COVER SHEET
OF
FREEMAN LOGISTICS
PTNS. OF THE SE1/4, OF SEC. 17, TWP. 20 N., RGE 4 EAST, W. M.
AND PTNS. OF THE NE1/4, OF SEC. 20, TWP. 20 N., RGE 4 EAST, W. M.
PIERCE COUNTY, WASHINGTON

Title: **COVER SHEET**

FREEMAN LOGISTICS

Sheet C7 of 35

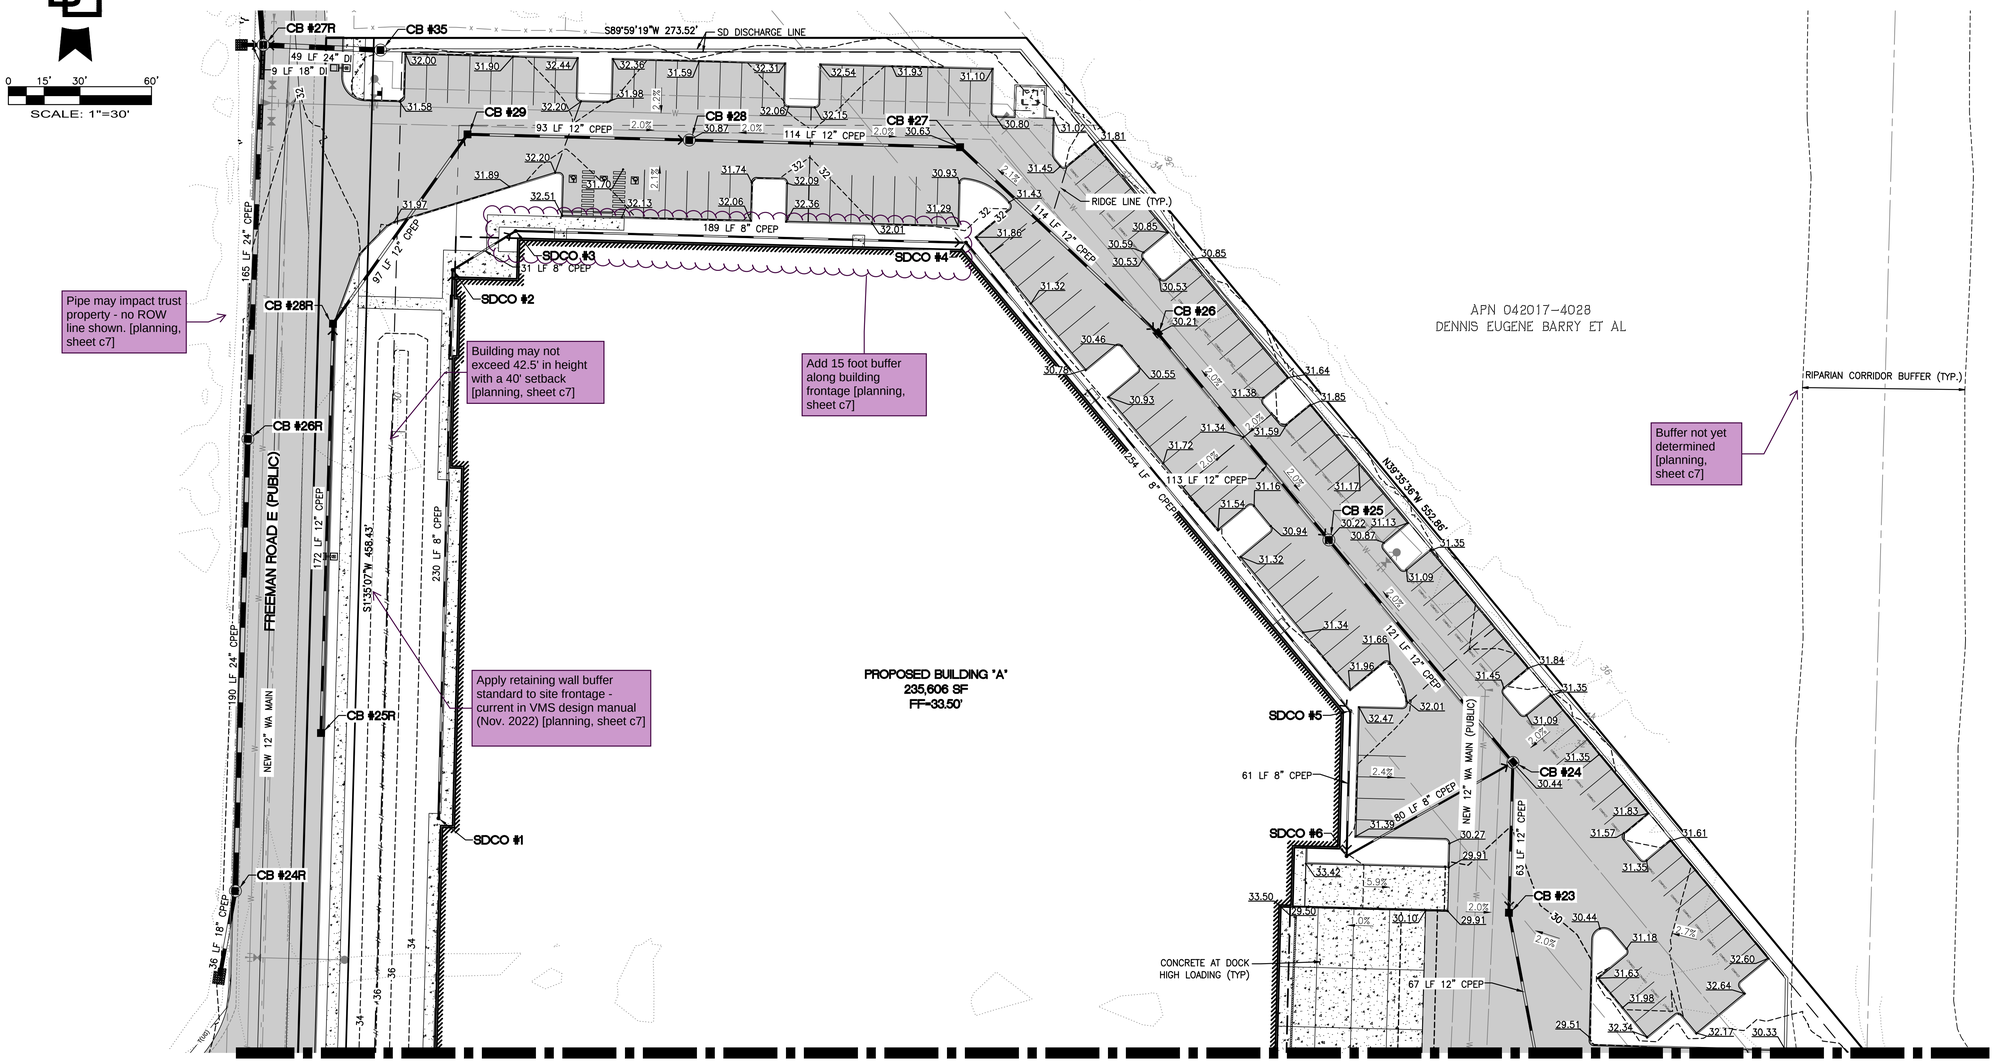
Pipe may impact trust property - no ROW line shown. [planning, sheet c7]

Building may not exceed 42.5' in height with a 40' setback [planning, sheet c7]

Add 15 foot buffer along building frontage [planning, sheet c7]

Apply retaining wall buffer standard to site frontage - current in VMS design manual (Nov. 2022) [planning, sheet c7]

Buffer not yet determined [planning, sheet c7]

Job Number 21585
Sheet C8 of 35

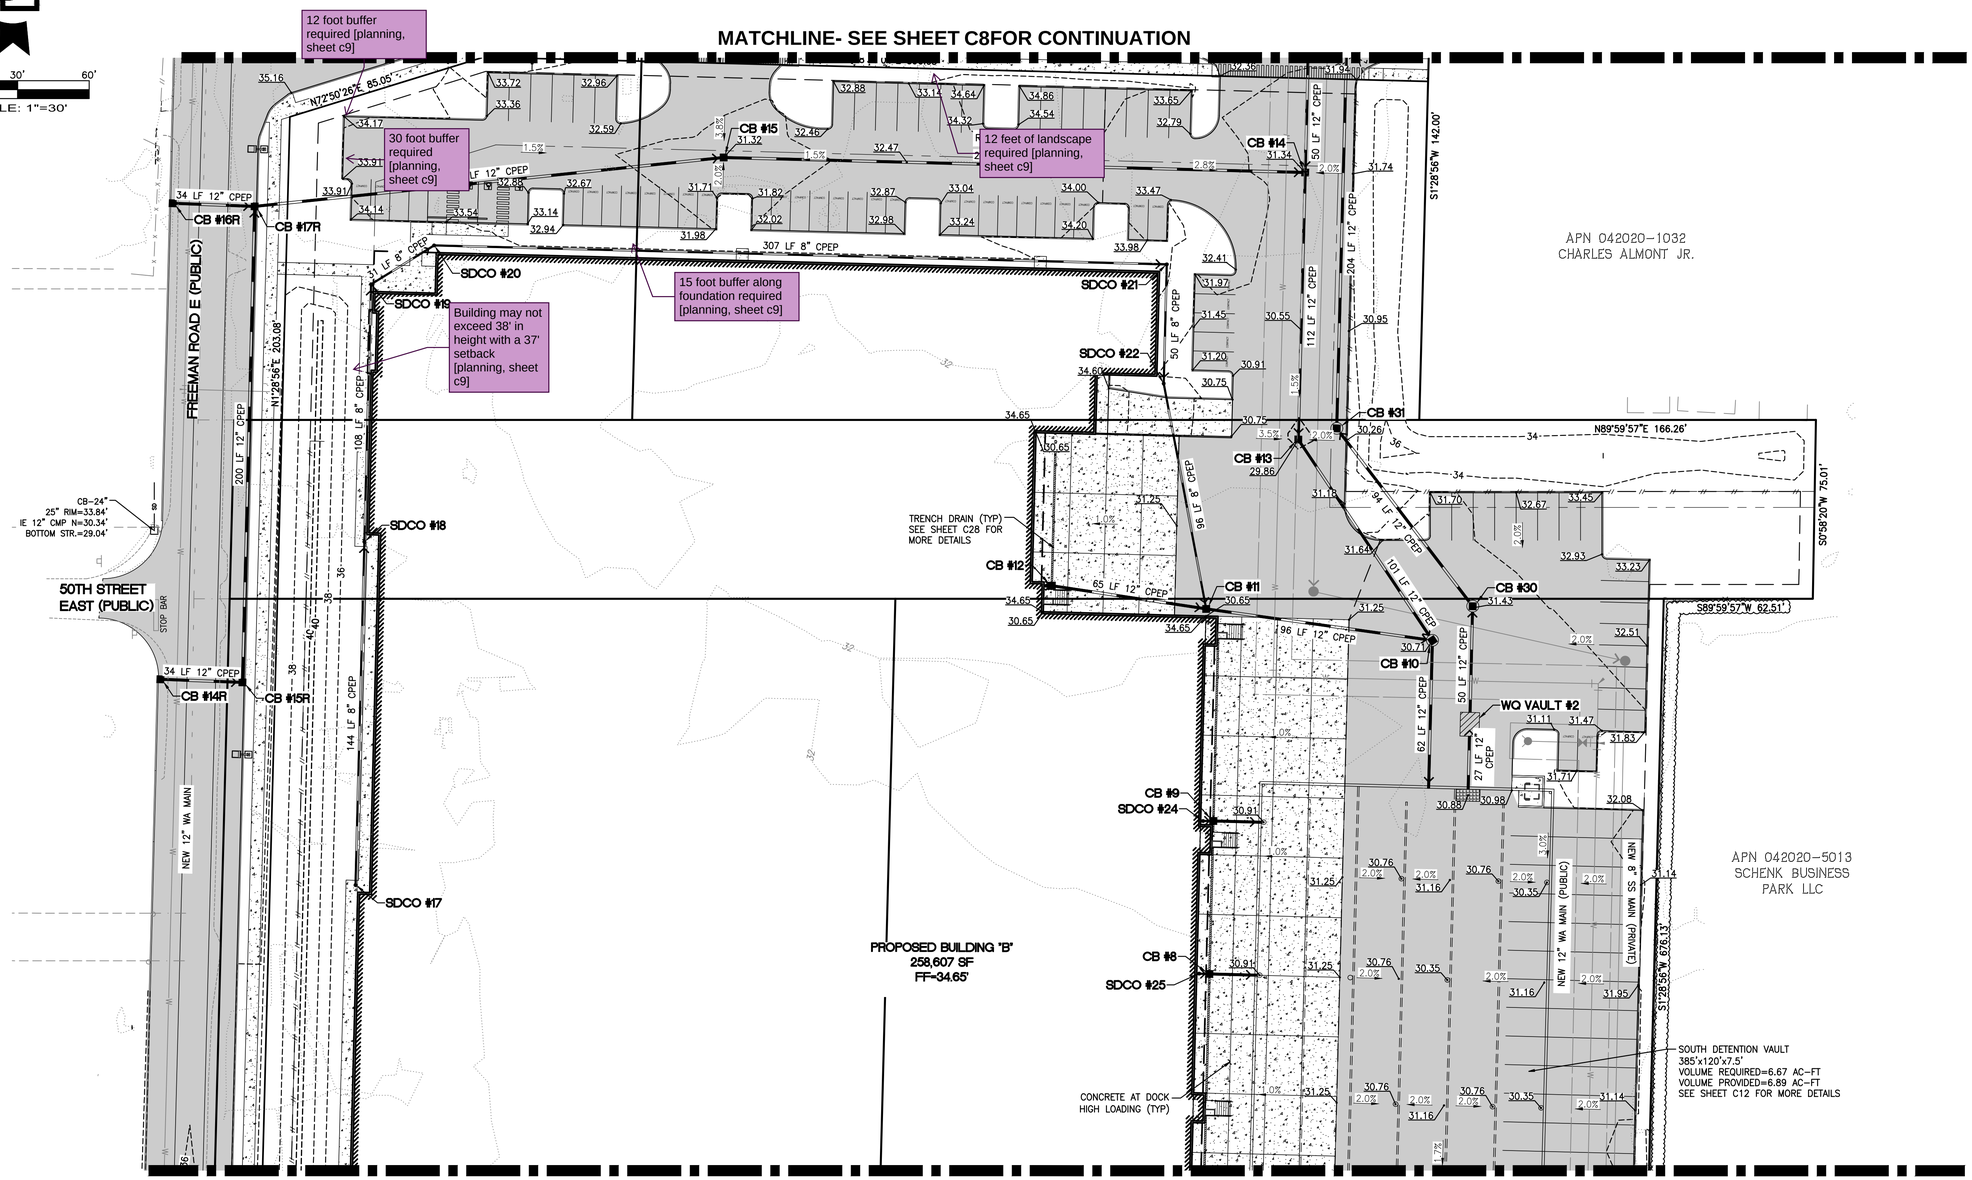
48TH STREET EAST (PUBLIC)
STOP BAR
NEW 12" WA MAIN
35 LF 12" CPEP
CB #22R
CB #23R
157 LF 12" CPEP
144 LF 8" CPEP
SDCO #11
ROOF DRAIN LINE (TYP.)
PROPOSED BUILDING "A"
235,606 SF
FF=33.50'
SDCO #12
34 LF 12" CPEP
CB #20R
CB #21R
S1°28'56"W 365.73'
132 LF 12" CPEP
86 LF 8" CPEP
FREEMAN ROAD E (PUBLIC)
30 feet of landscape required - ADA stalls and walkway must be set back [planning, sheet c8]
SDCO #13
SDCO #14
273 LF 8" CPEP
CB #18
CB #19R
CB #18R
34 LF 12" CPEP
115 LF 12" CPEP
12 feet of landscape required [planning, sheet c8]
Δ=89°59'43" R=20.00' L=31.41'
5' SIDEWALK

4.5' PLANTER
22ND AVE NW (PUBLIC)
8 foot walk, 6 foot planter required [planning, sheet c8]
60' R/W
CB #22
SDCO #7
101 LF 12" CPEP
RIPARIAN CORRIDOR BUFFER (TYP.)
Buffer not yet determined [planning, sheet c8]
CB #21
SDCO #8
100 LF 12" CPEP
NEW 12" WA MAIN (PUBLIC)
Truck parking must be broken apart with landscape islands every 8 stalls [planning, sheet c8]
STORM PUMP DISCHARGE LINE
TRENCH DRAIN (TYP) SEE SHEET C28 FOR MORE DETAILS
SDCO #9
CB #20
99 LF 12" CPEP
N1°00'44"E 460.27'
NORTH DETENTION VAULT
356'X100'X7.5'
VOLUME REQUIRED=5.13 AC-FT
VOLUME PROVIDED=5.31 AC-FT
SEE SHEET C11 FOR MORE DETAILS
APN 042020-0110 STATE OF WASHINGTON DOT
CONCRETE AT DOCK HIGH LOADING (TYP)
CB #19
SDCO #10
98 LF 12" CPEP
SDCO #15
SDCO #16
63 LF 8" CPEP
25 LF 8" CPEP
NEW 6" SS SERVICE
31 LF 12" CPEP
150 LF 12" CPEP
236 LF 12" CPEP
CB #17
RIDGE LINE (TYP.)
Move line out of planter [planning, sheet c8]
50 LF
S8
CB #16
CB #33
CB #34
14 LF 12" CPEP
28 LF 12" CPEP

WQ VAULT #1
PUMP CONTROL PANEL AND PADS FOR EMERGENCY POWER
Off site wetland on WSDOT property may extend buffer into this area of the site [planning, sheet c8]
128 LF 12" CPEP
PUMP VALVE VAULT
STORM DUPLEX LIFT STATION
FULLY SUBMERSIBLE PUMPS
WITH VARIABLE FREQUENCY
DRIVE AND FLOAT SWITCH
S1°28'56"W 28.56'
N89°59'57"E 110.60'
APN 042020-0111 STATE OF WASHINGTON DOT
Are these emergency generators? Relocate away from residential land uses [planning, sheet c8]
APN 042020-1032 CHARLES ALMONTJR
100 LF 12" CPEP
NEW 12" WA MAIN
CB #31R
CB #32R
CB #32
CB #29R
190 LF 12" CPEP
CB #30R
S88°31'04"E 396.03'
30 feet of dense evergreen landscape with fence required. Proposed location of lines will reduce available planting area due to spacing requirements [planning, sheet c8]

Sheet C13 of 35

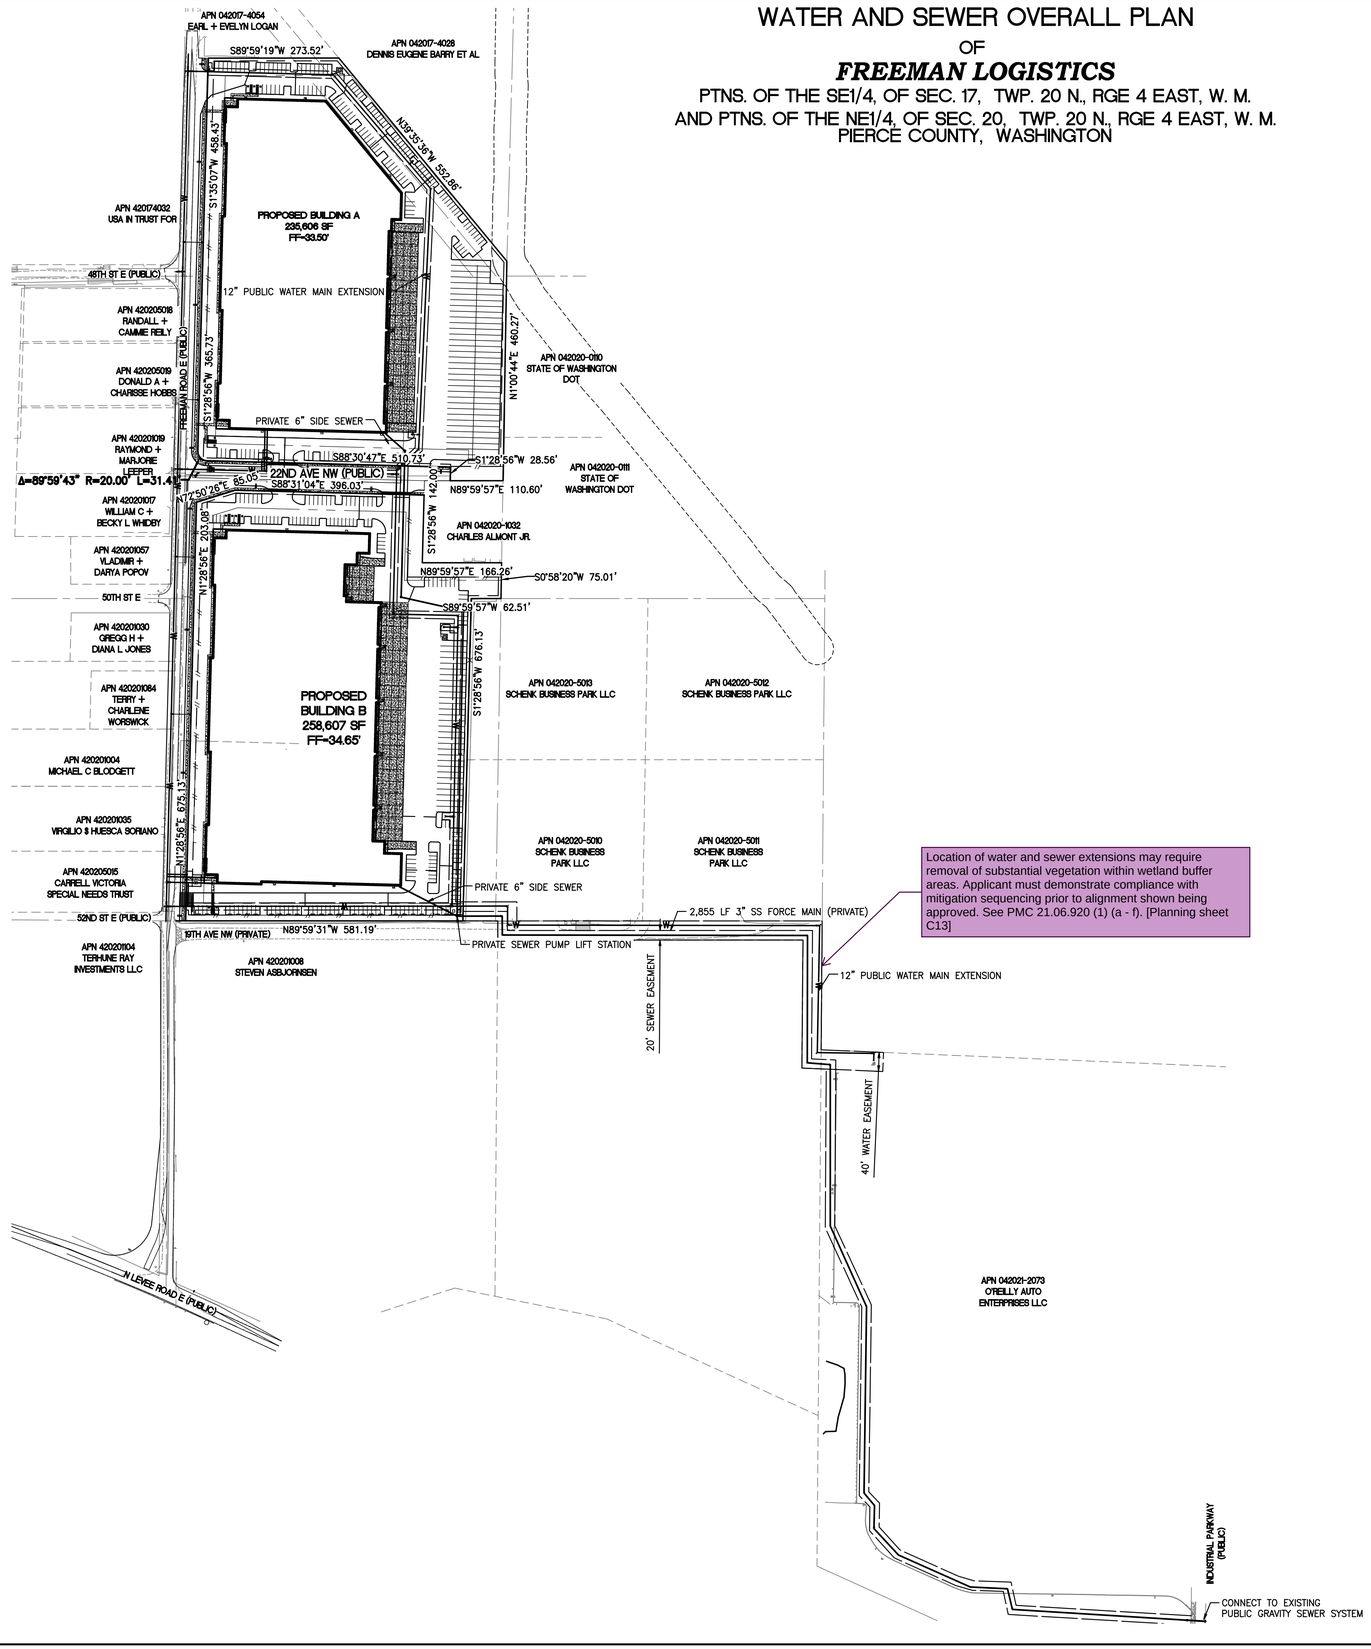
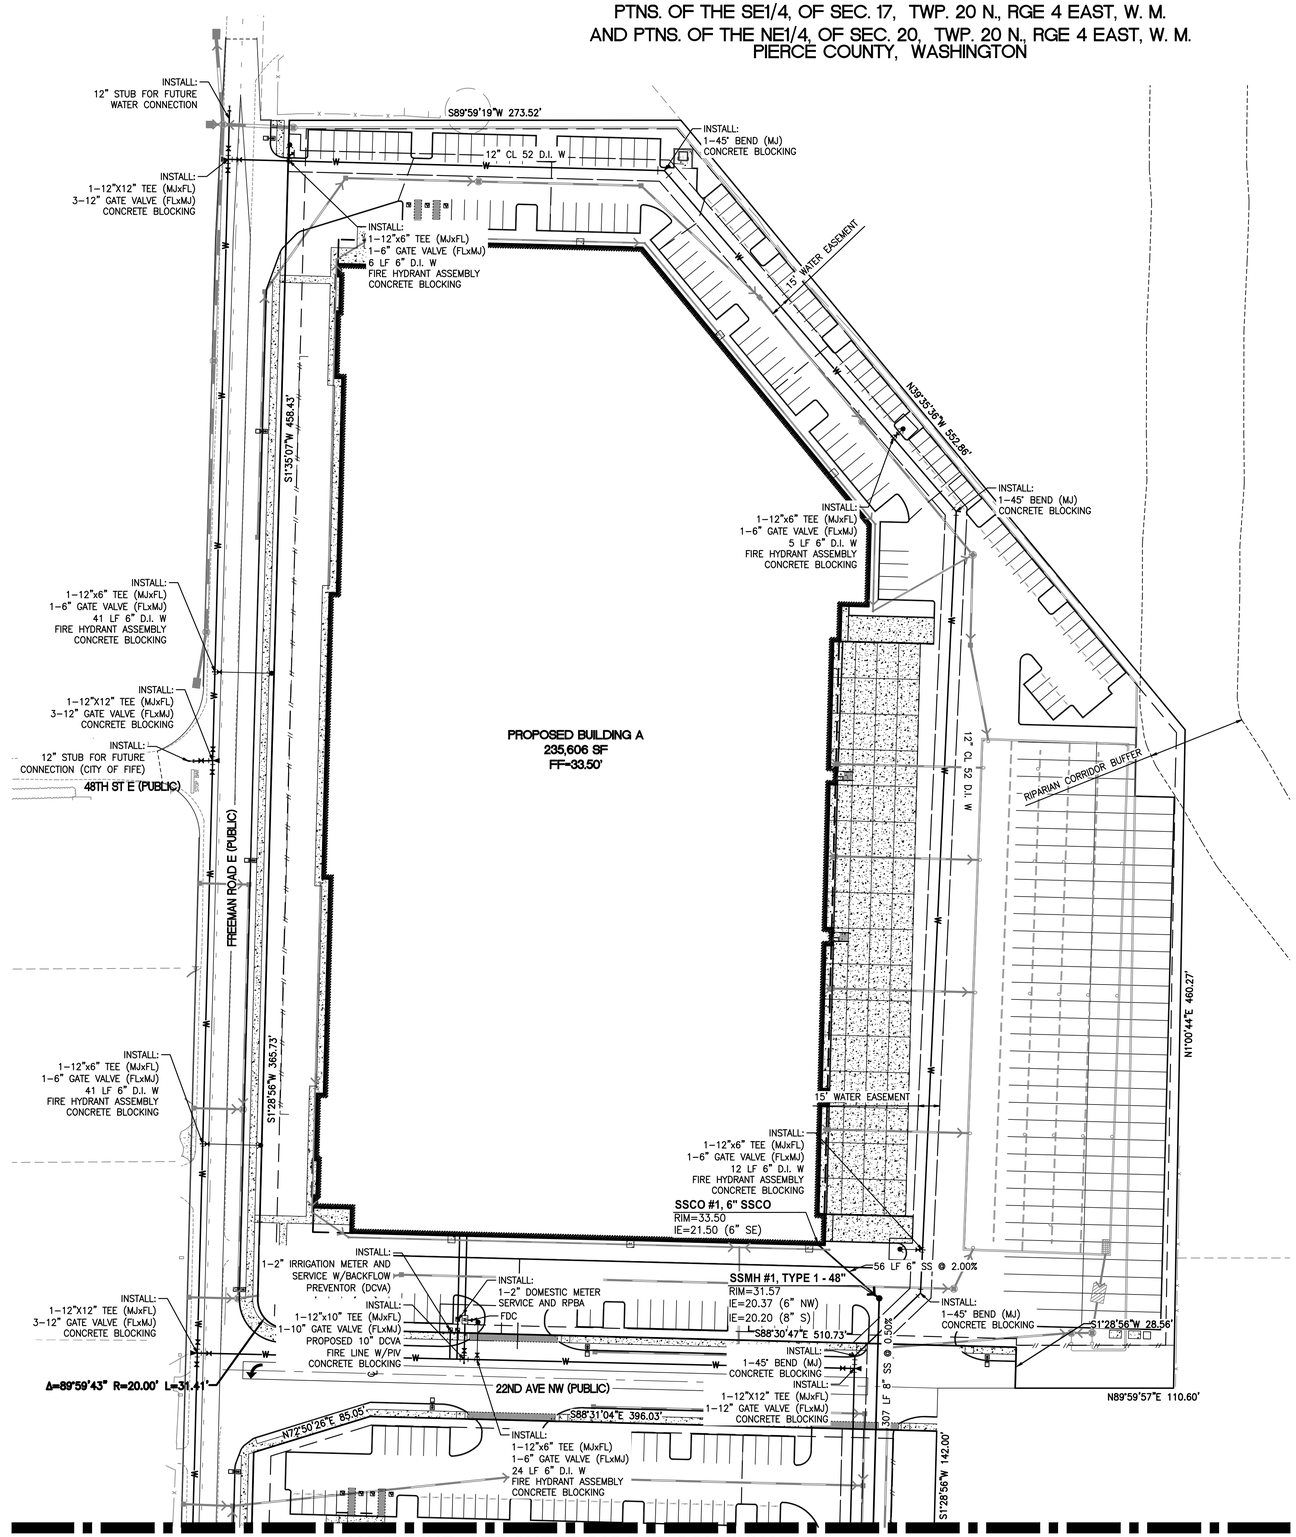
Location of water and sewer extensions may require removal of substantial vegetation within wetland buffer areas. Applicant must demonstrate compliance with mitigation sequencing prior to alignment shown being approved. See PMC 21.06.920 (1) (a - f). [Planning sheet C13]
